Modification Recommended Service Note

N8952A - Autoranging System DC Power Supply, 200V, 210A, 15000W, 400 VAC

Serial Numbers: DE14290000 - DE15369999 without manufacturing ID Version "B"

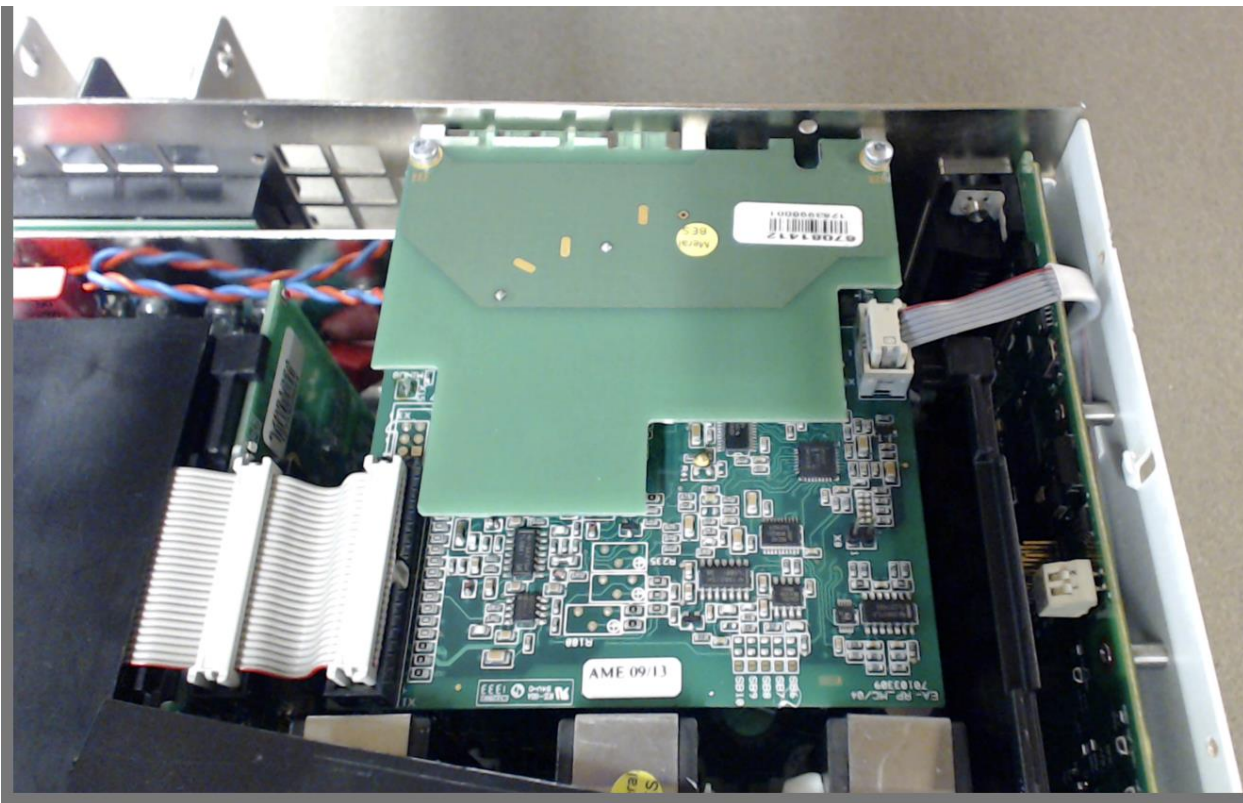
Resistors R93 and R94 must be removed, no replacement parts are required for modification.

Removal of two (2) surface mount resistors, R93 and R94, will correct this problem:

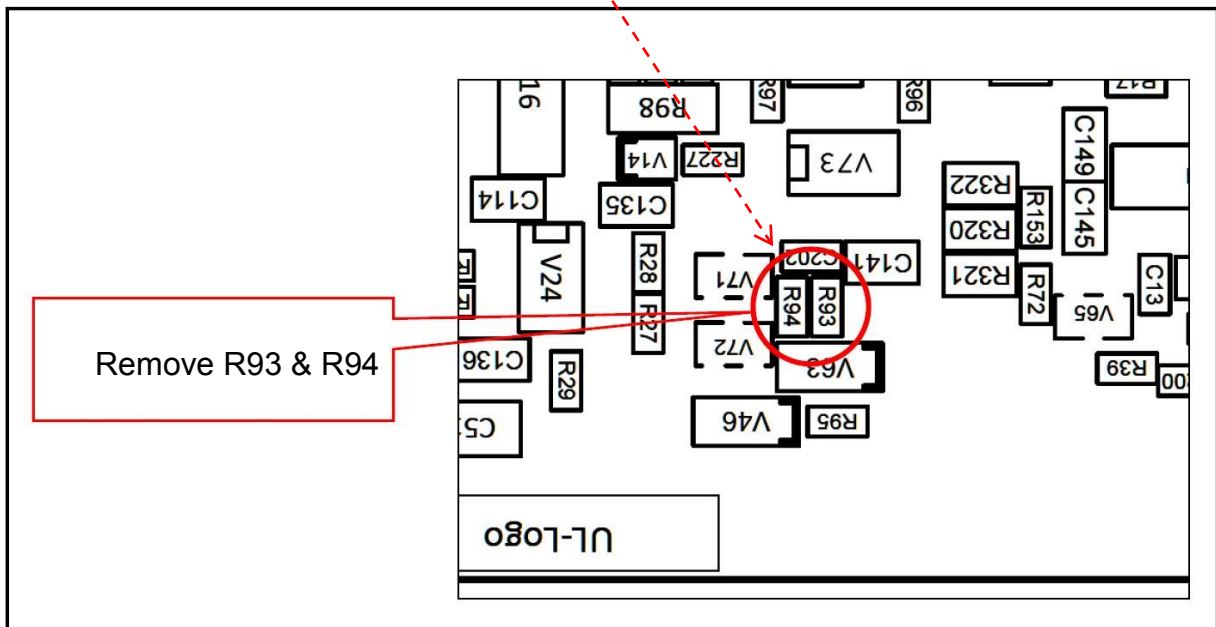
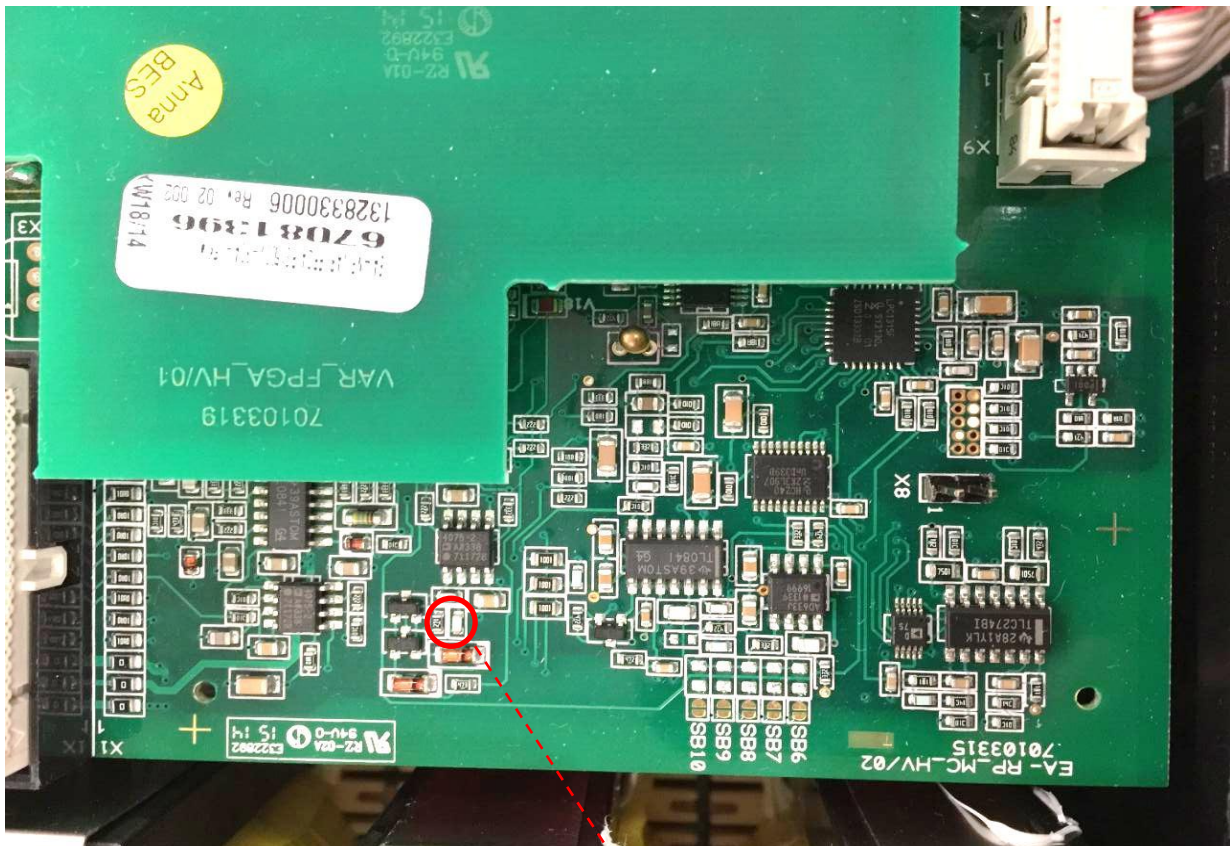
- 1) Remove acMains cable from power source.
- 2) Wait 5 minutes
- 3) Remove top cover from instrument.
- 4) In the 5kW units (viewed from the front of the unit), a small SMT assembly located at the right-rear of instrument will be readily visible (see below):

In the 10kW & 15kW units; although found in the same location, a black plastic cover will have to be removed to gain visibility and access to the SMT assembly. Plastic cover snaps-on and can be removed with a small screwdriver.

Suffix “B” added

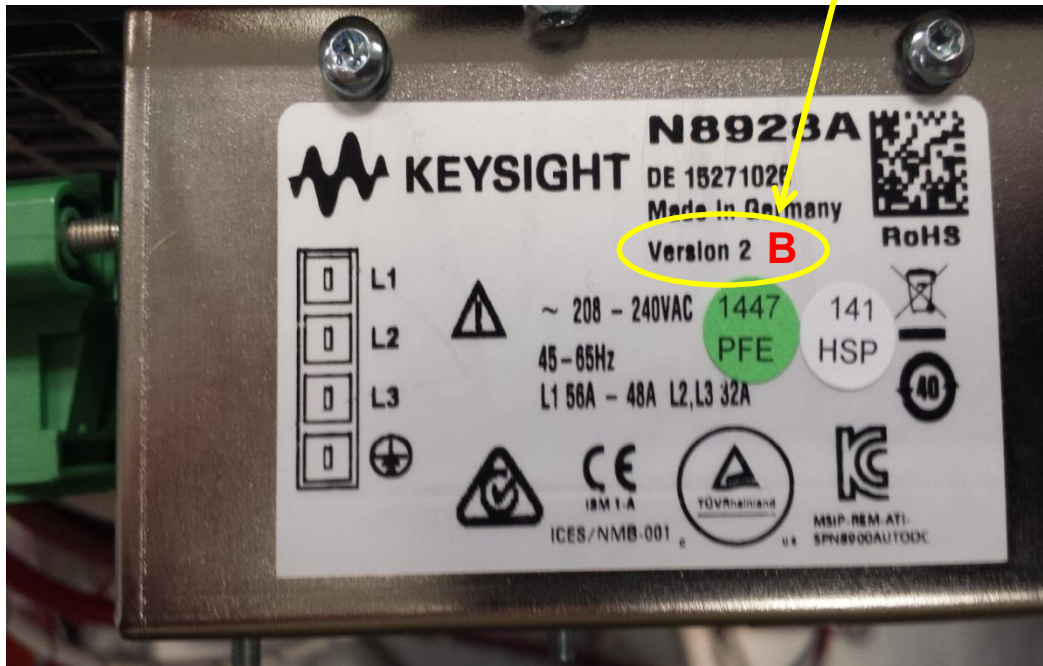
7) On the acMains label, on the rear of the instrument; use an indelible marker, to add the suffix letter “B” after the Version ID. This will assist in the tracking of modified instruments.
